PCN / EOL Notification

Product Change Notification Number: RC090302

Title: AT91SAM7XC Revision and Ordering Code Change

Top side marking:

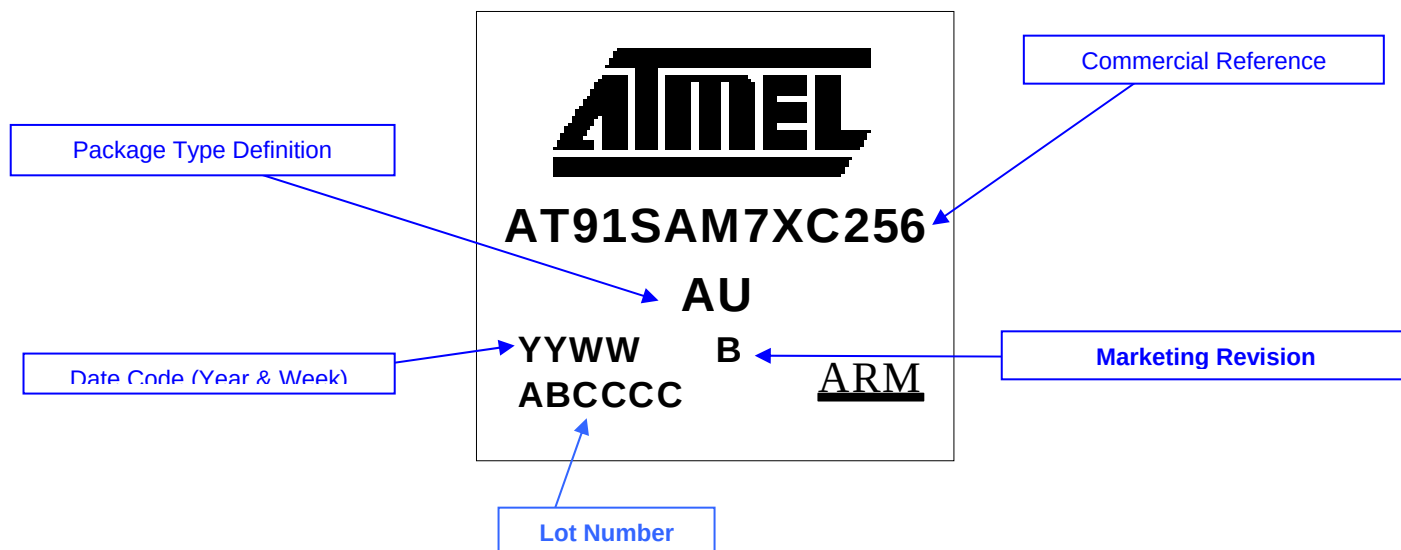
Marketing Revision on the topside marking will be incremented from A to **B**.
